**CITY OF LAS VEGAS' REPLY APPENDIX
VOLUME 7**

**RESPONSE TO 3RD CLV COMMENTS
ON THE
TECHNICAL DRAINAGE STUDY FOR THE 435
(FORMERLY "THE SEVENTY")**

**Re: 3rd Response to City of Las Vegas Comments on the
Technical Drainage Study for "The 435" (DS4787C)**

6'X6' RCB

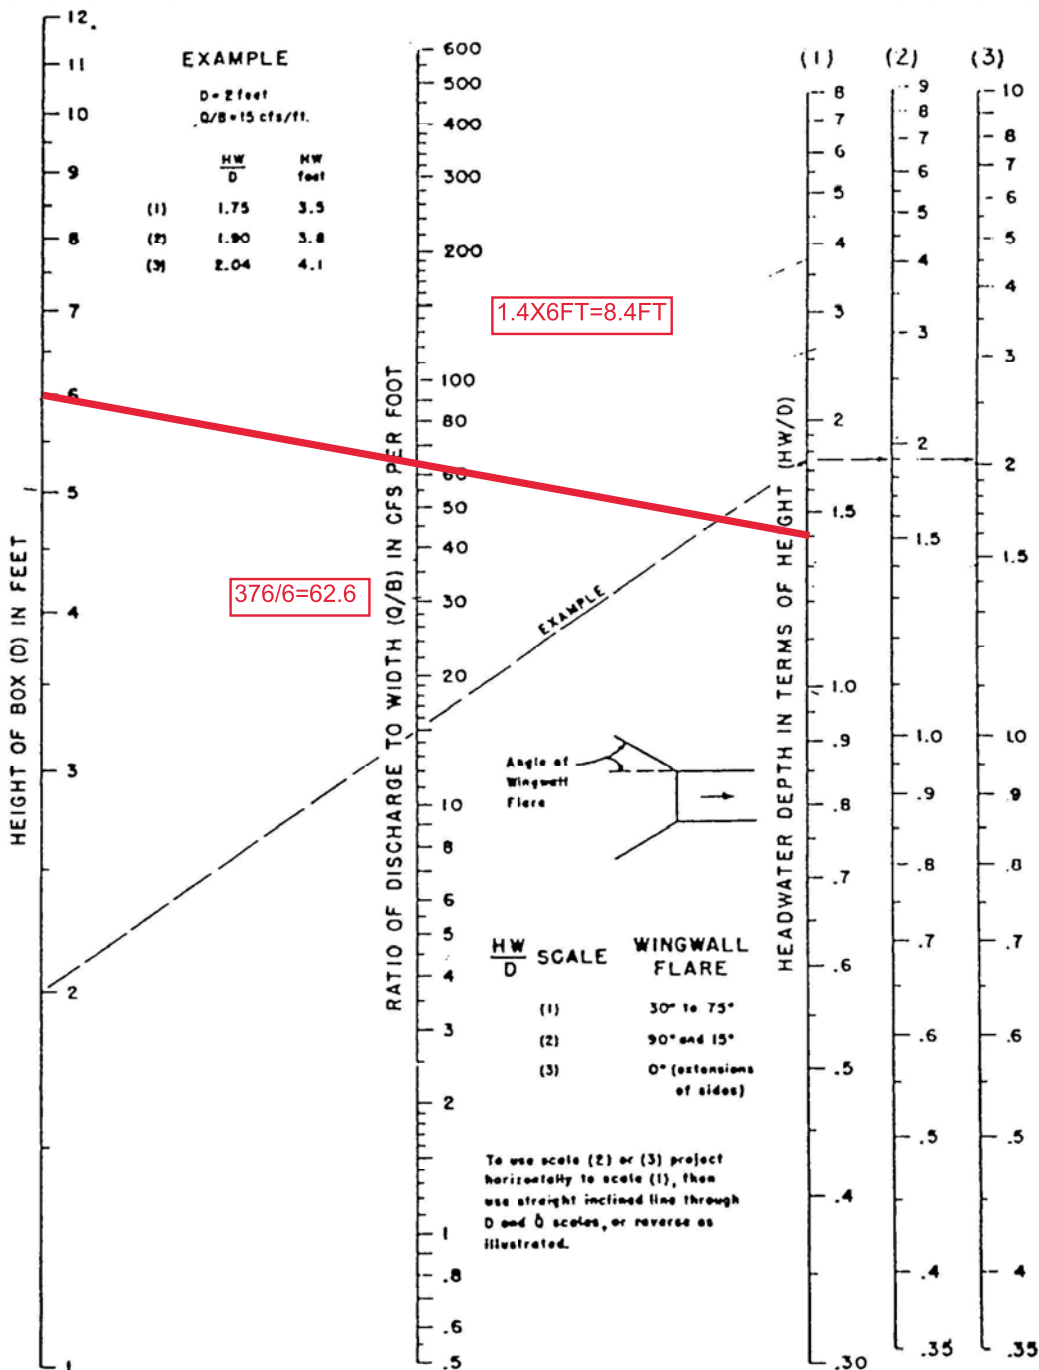
Comment: "11. Provide headwater calculations at the RCB entrance from the open box section."

Response: The open top RCB is no longer proposed. An inlet control calculation has been provided for the entrance of the newly proposed RCB extension.

SEVENTY ACRES, LLC
 THE 435
 PLAN & PROFILE OVERALL
 DRAWING C5.00
 8 OF 22 SHEETS

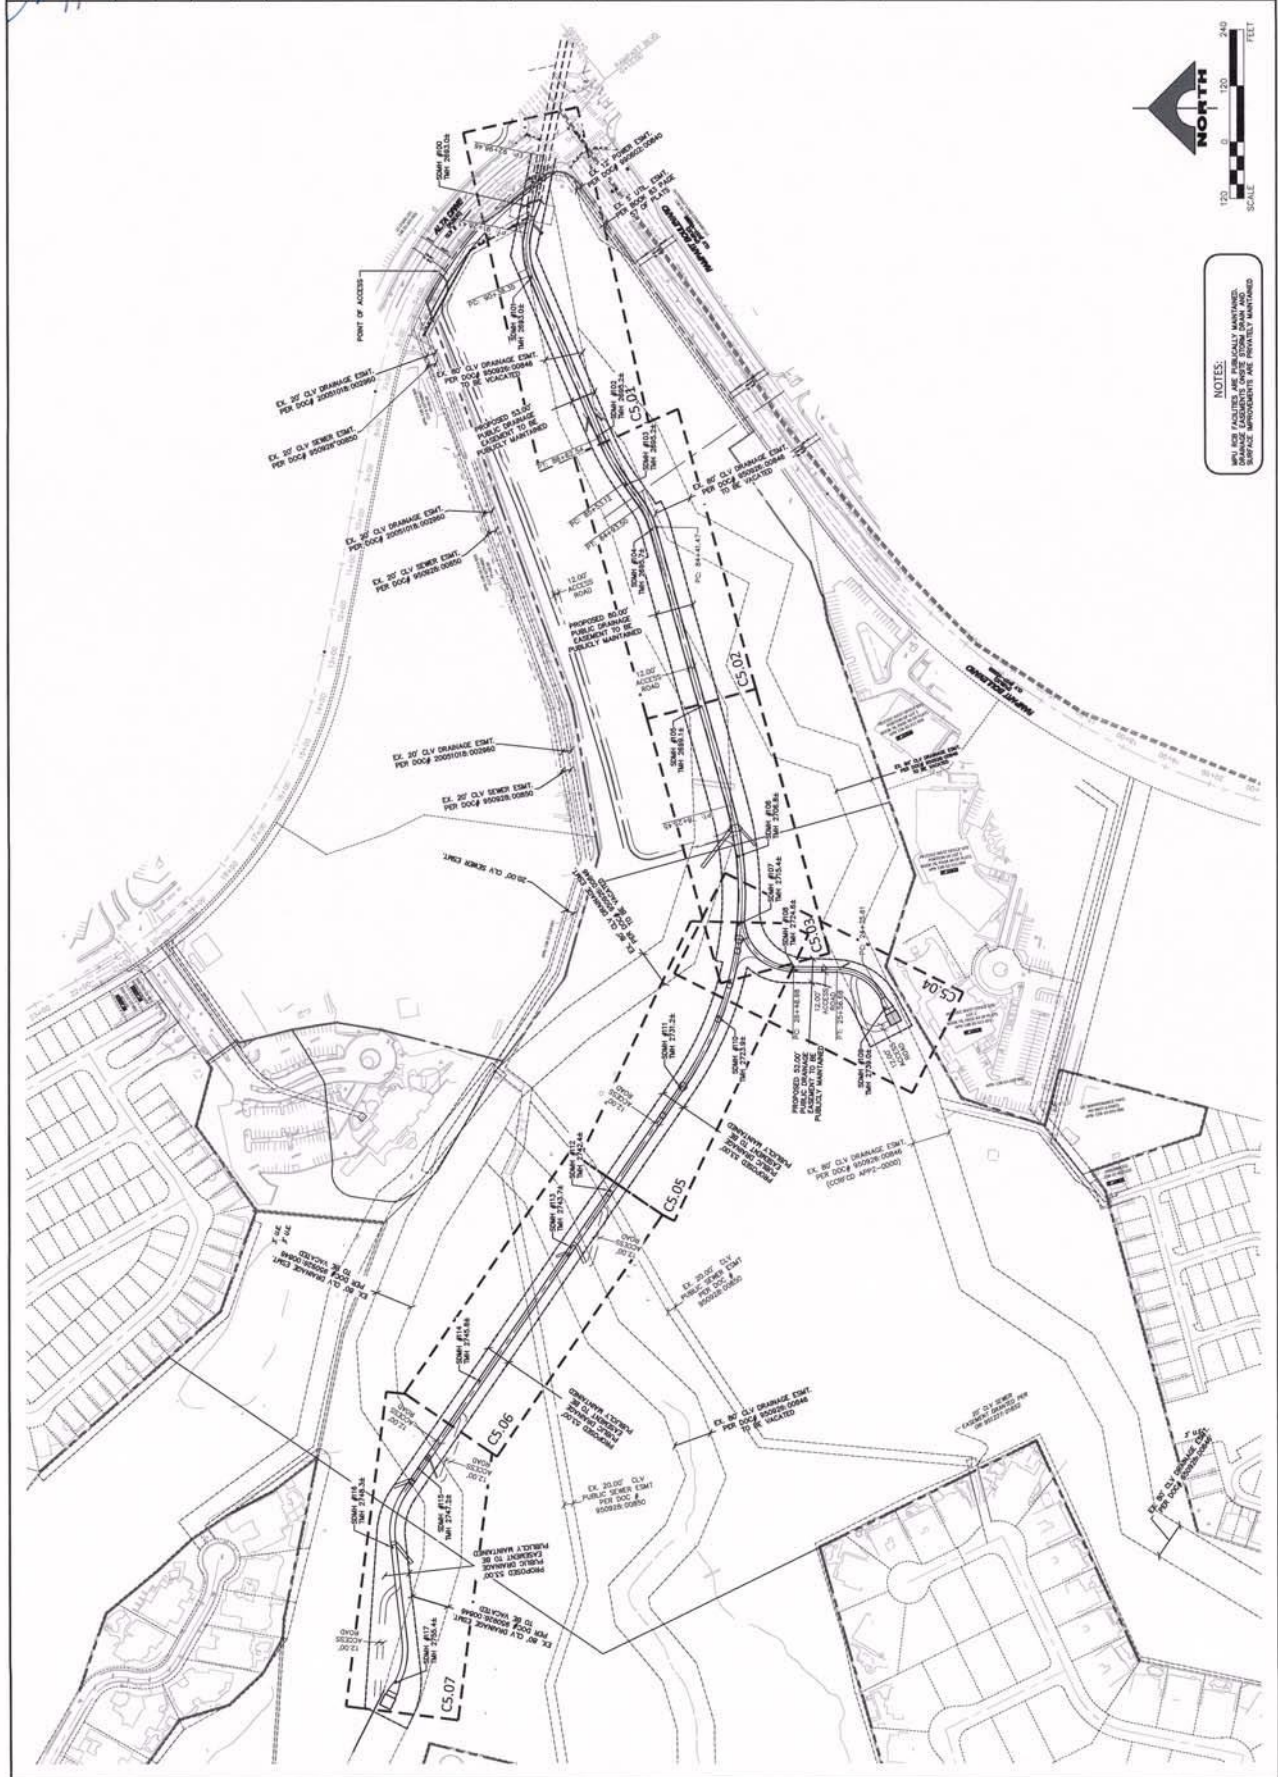
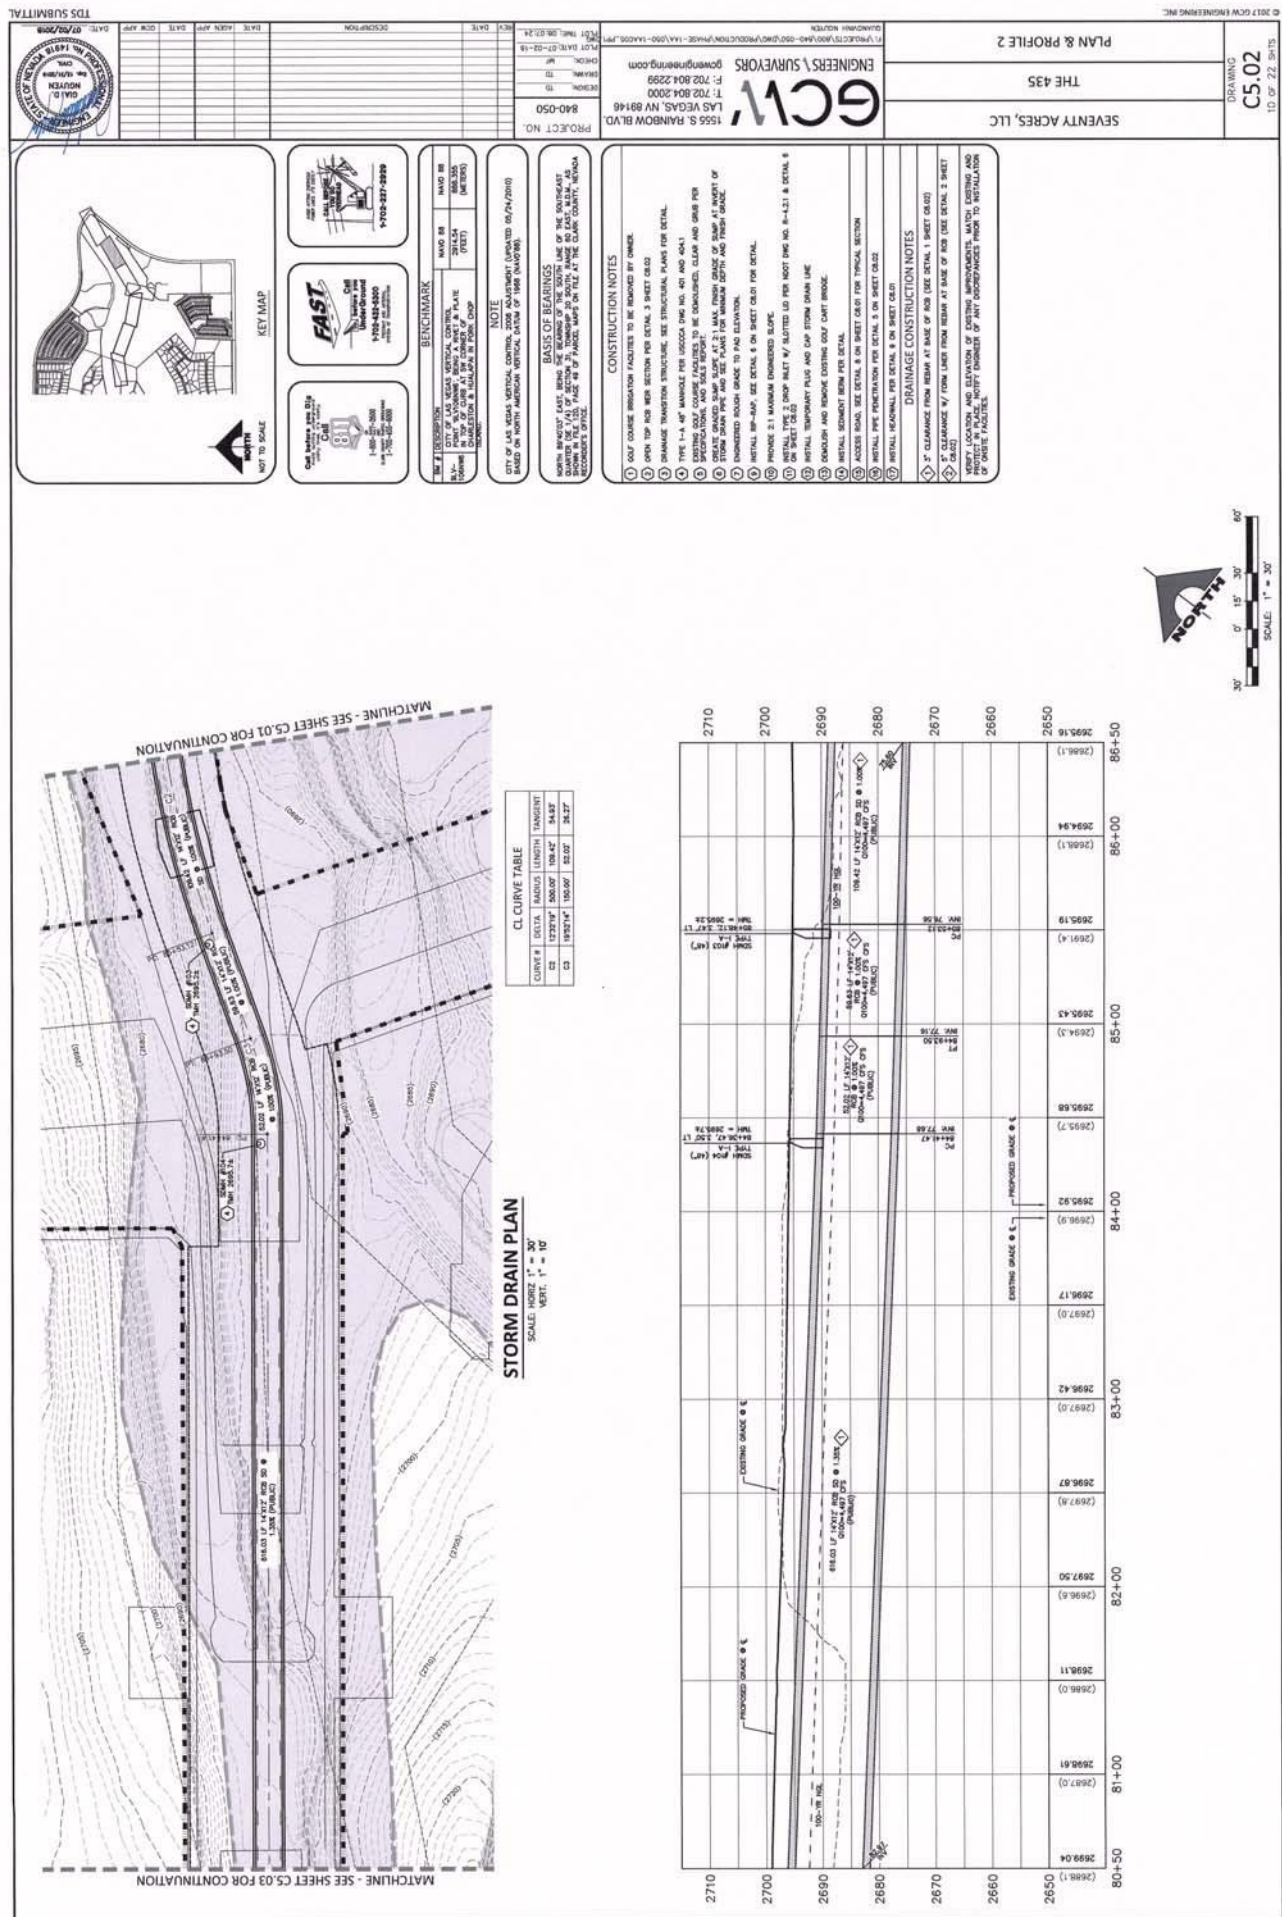
Comment: "19. It is unclear on the profile on Sheet C5.03 where the bottom of the channel is located and how high the HGL is at this section. It appears that the upstream end of the open box is only 2-feet high which means the western wall of the RCB is not fully constructed. Clarify the design of open box section."

Comment: "20. Verify the stationing of SDMH #109 on the profile on Sheet C5.04."

Response: Comment no longer applicable due to design change.

Response: The stationing of SDMH #109 has been corrected.

STORM DRAIN - LATERAL 8

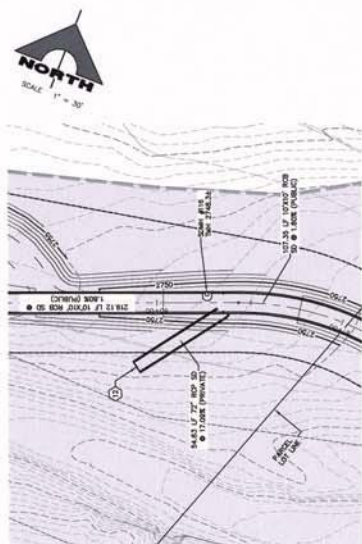
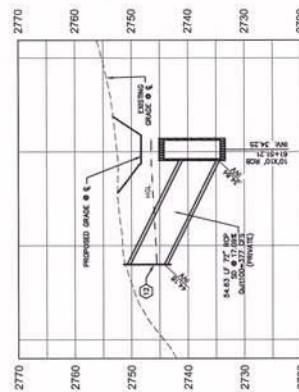
Comment: "21. Revise the call outs on the lateral profile sheets to call out Construction Note 12 to install temporary plug and cap storm drain line."

24. Label Laterals 5 through 9 on the plan and profile to correspond to the lateral profiles on Sheets C5.010 and C5.11.
25. Provide stationing on all lateral profiles. Lateral profiles shall be based on the mainline stationing with corresponding offsets and angles.

Response: The call outs on the lateral profile sheets have been revised to call out construction note 12.
